M-9A0 (Calpella + N11P/M Discrete Graphic)

FOXCONN		HON HAI Precision Ind. Co., Ltd.	
		CCPBG - R&D Division	
Title ARD (CLK,MISC,JTAG)			
Size	Document Number	Rev	
Custom	M9A0 MP	1.1	
Date:	Thursday, November 19, 2009	Sheet	3 of 73

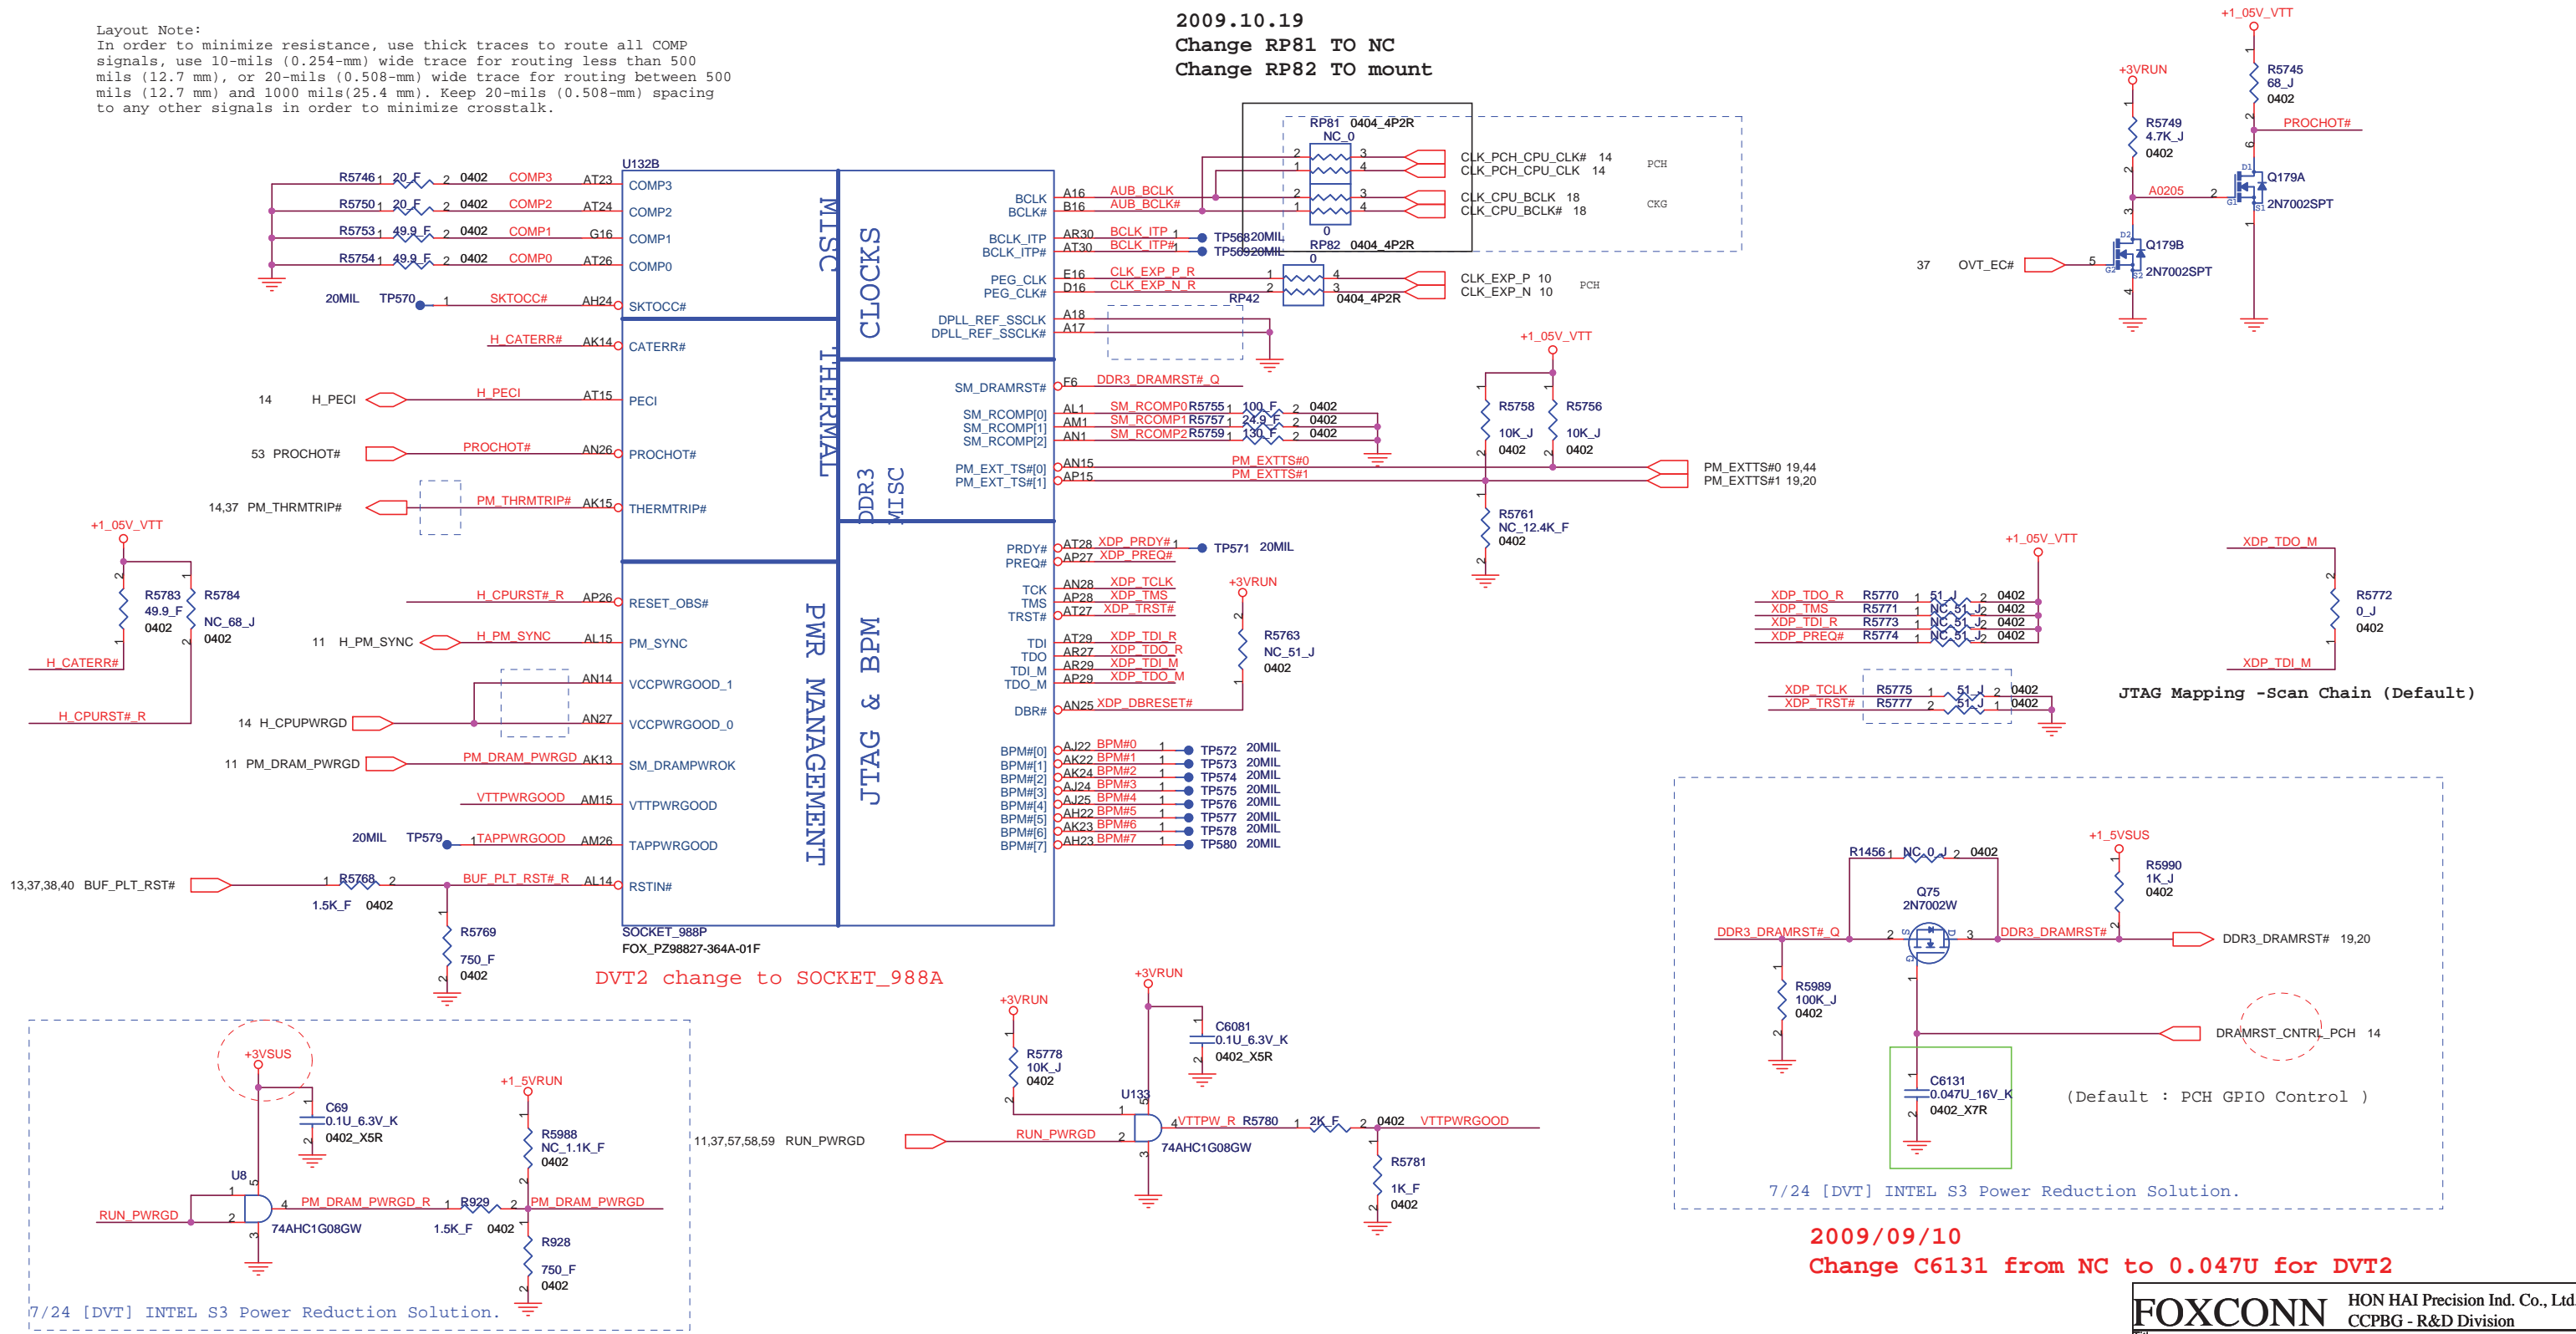
2009.10.19
 Change RP81 TO NC
 Change RP82 TO mount

2009/09/10
 Change C6131 from NC to 0.047U for DVT2

FOXCONN		HON HAI Precision Ind. Co., Ltd.	
		CCPBG - R&D Division	
Title ARD(POWER)			
Size	Document Number	Rev	
Custom	M9A0 MP	1.1	
Date:	Wednesday, October 28, 2009	Sheet	5 of 73

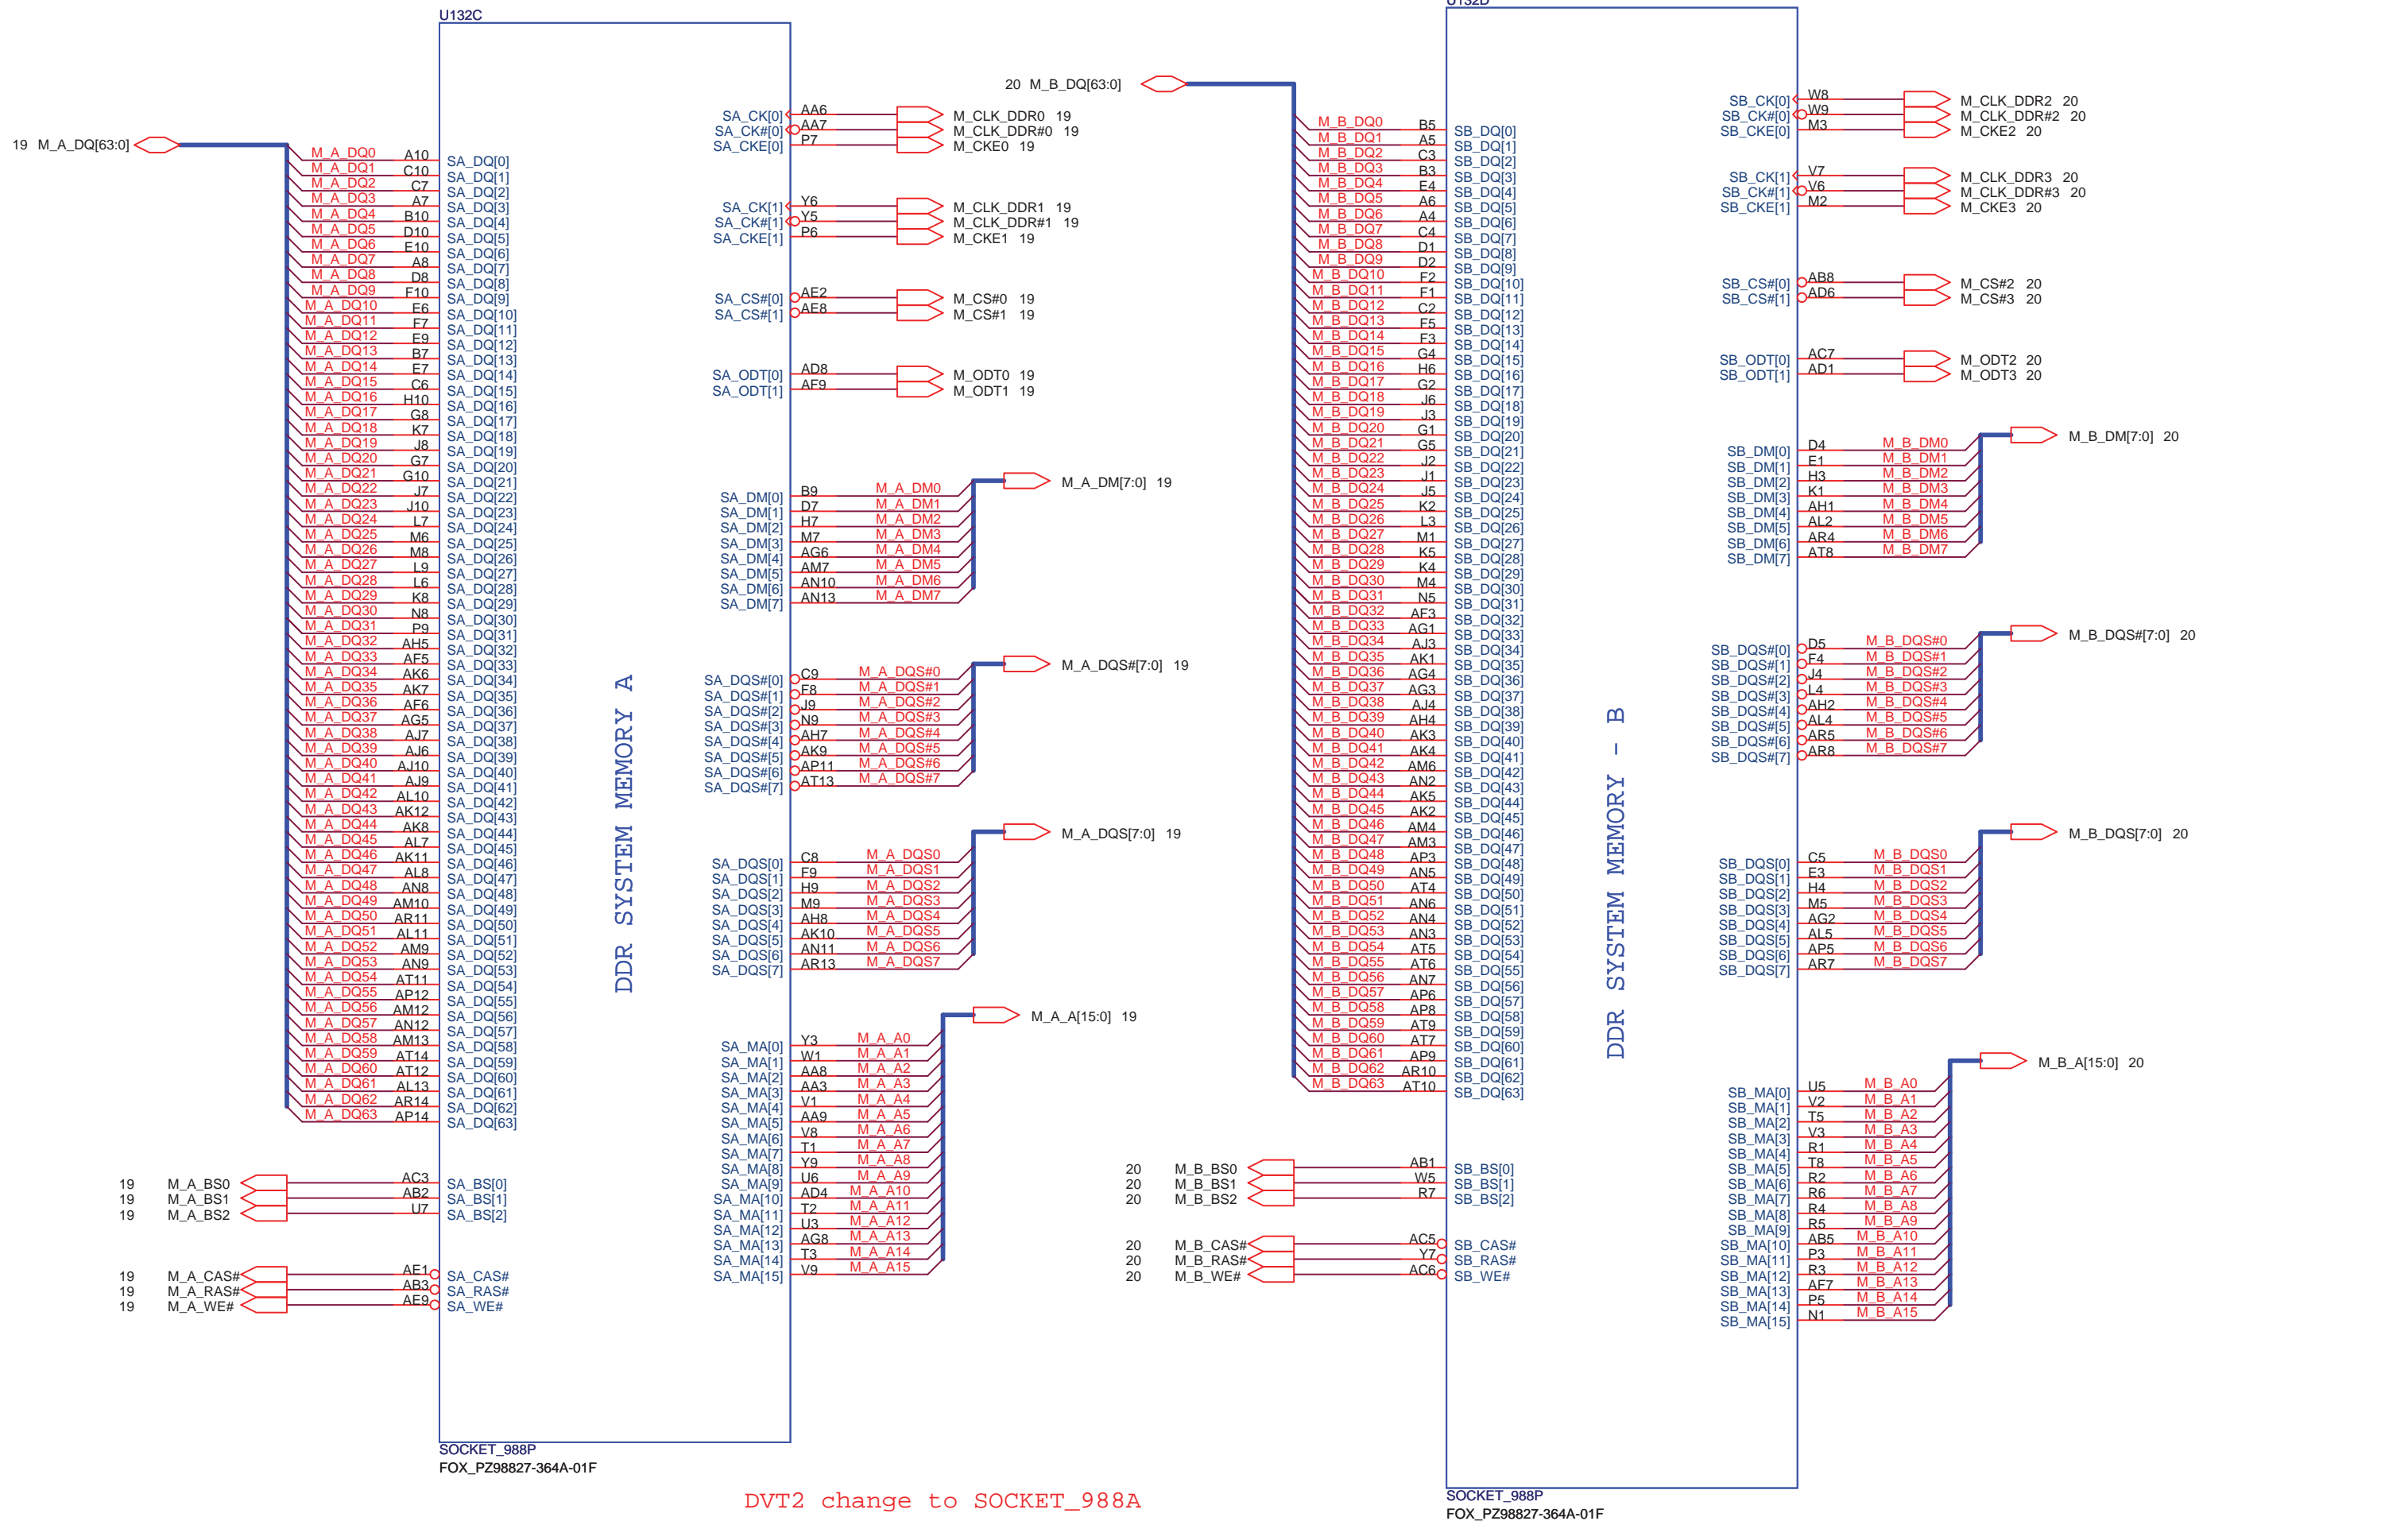
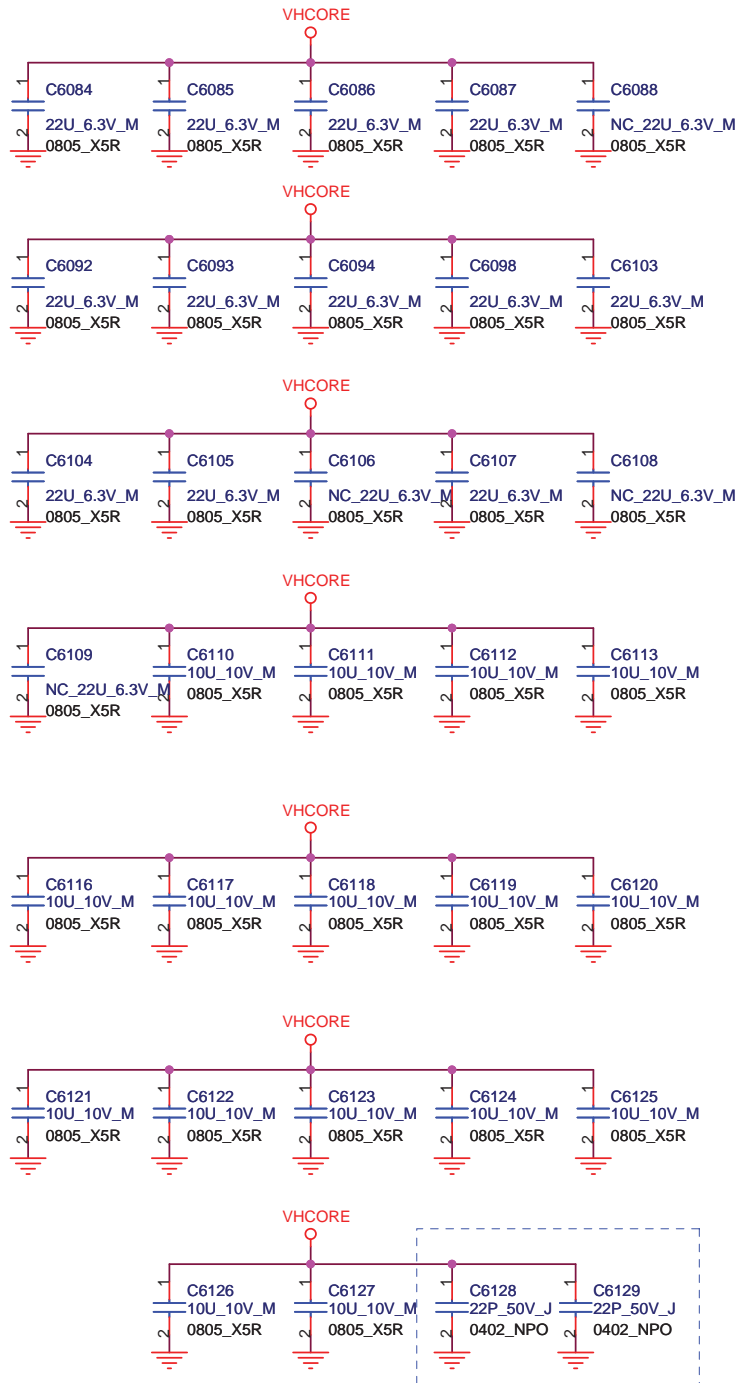
2009.10.23
Delete R5786 for PVT

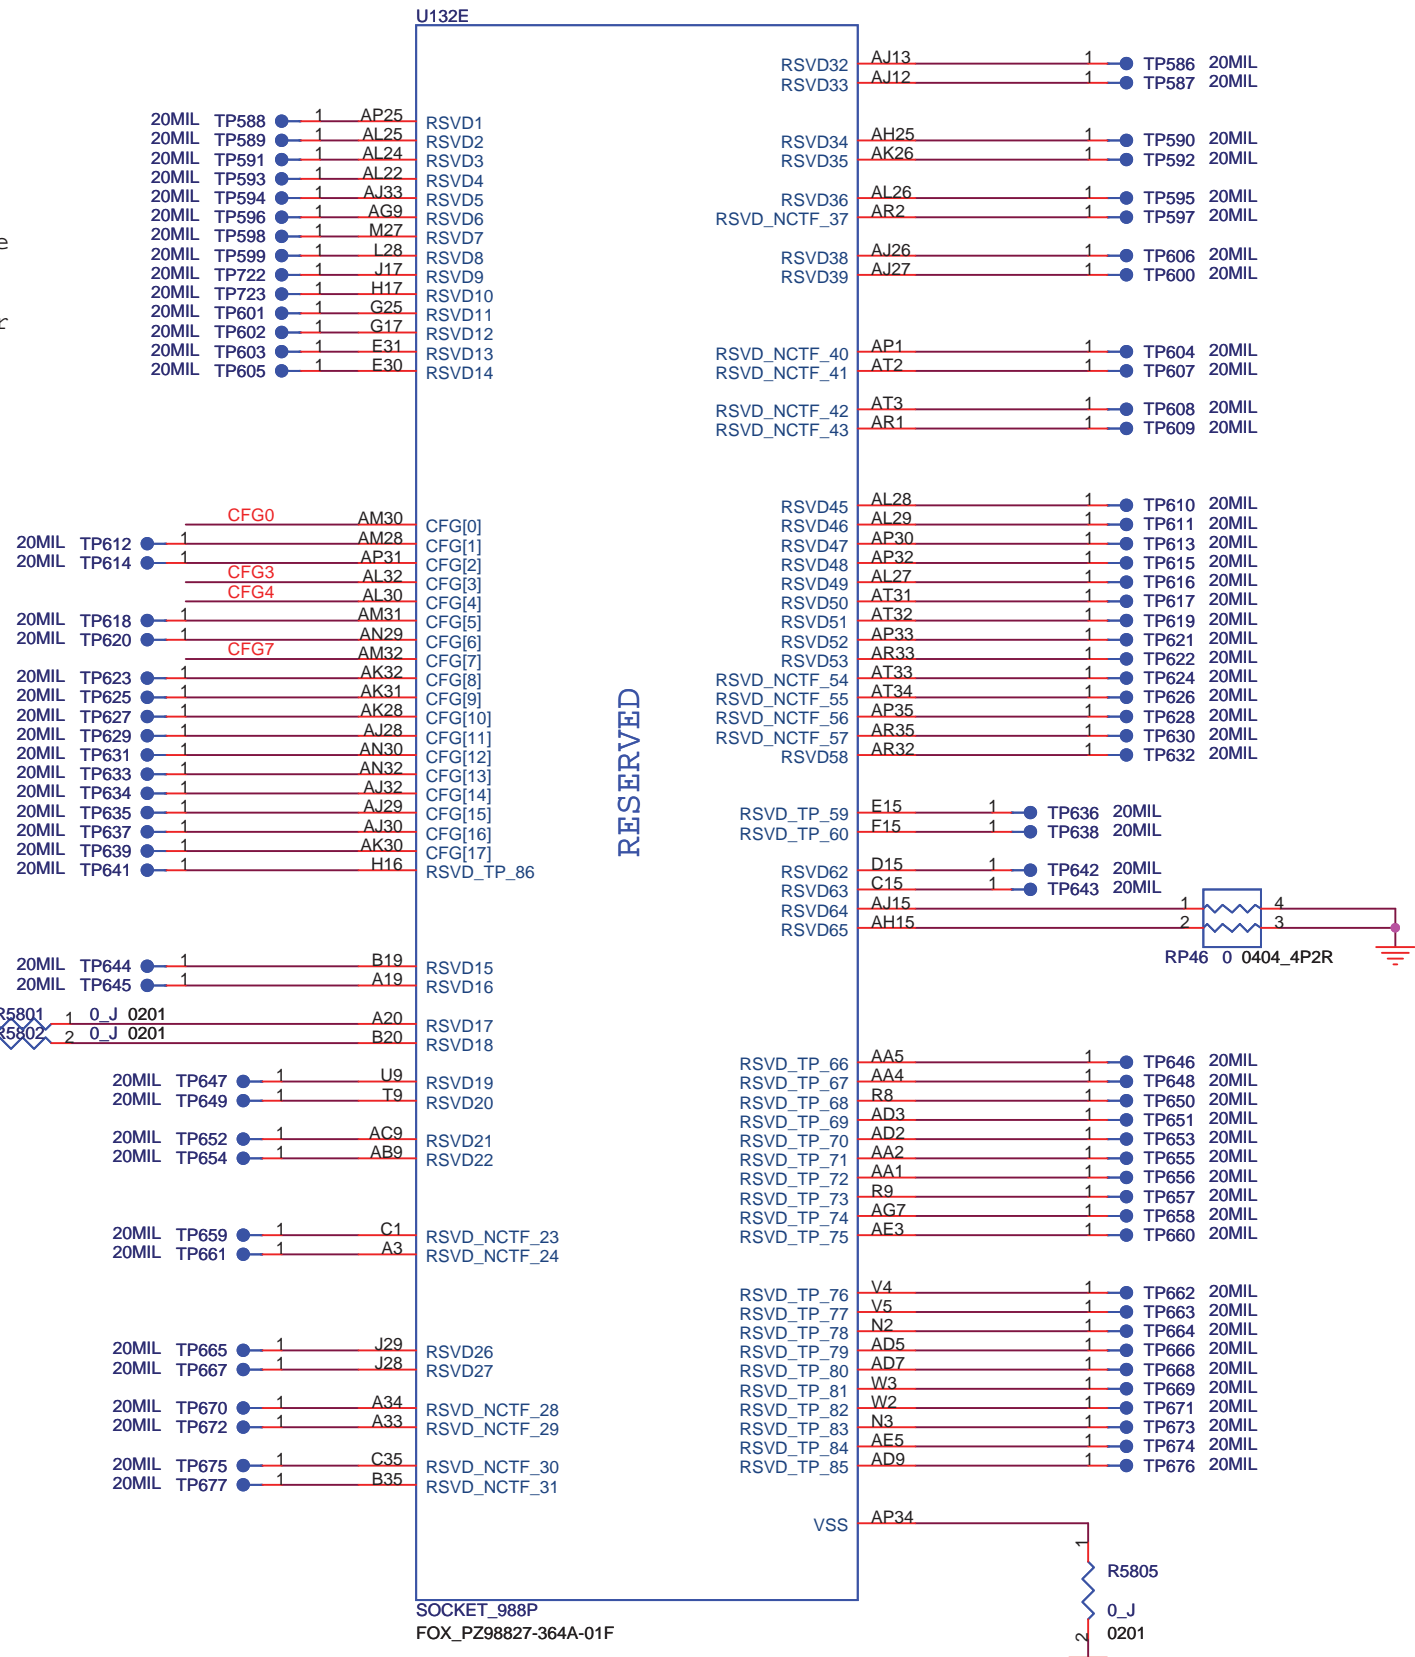
2009.0925
change C6156, C6157 from 12p to 15p for vendor request
